Addendum 1

PROJECT(S): **Gaston County Schools
2025 Cafeteria Cooler Freezer Replacement Projects**

PROJECT NO: Little Job Number: **112-20907-00**

ADDENDUM NO: **1**

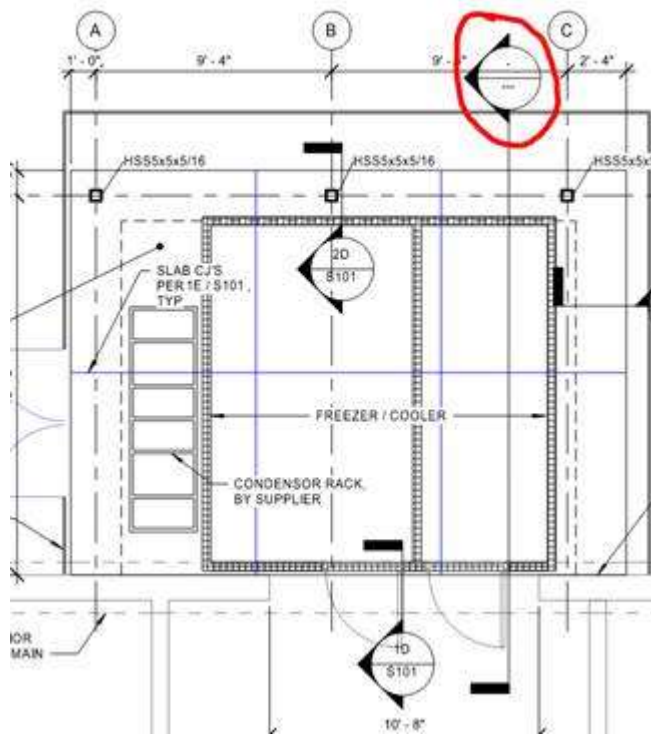
8. 1A/S101 -Partial foundation plan is missing details ,see attached below. Is this a typo?

Response: This section cut can be regarded as a typo for now, however, section details for this area are provided for both the foundation and roof framing plans via details 1E, 2E, 1D, 2D, and 4D on sheet S101.

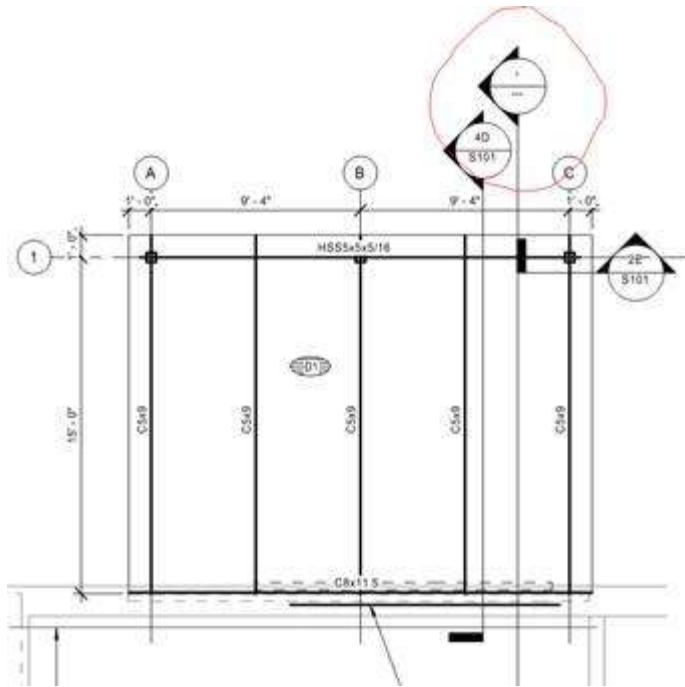
9. 3A/S101 -Partial roof framing plan is missing details, see attached below. Is this a typo?

Response: This section cut can be regarded as a typo for now, however, section details for this area are provided for both the foundation and roof framing plans via details 1E, 2E, 1D, 2D, and 4D on sheet S101.
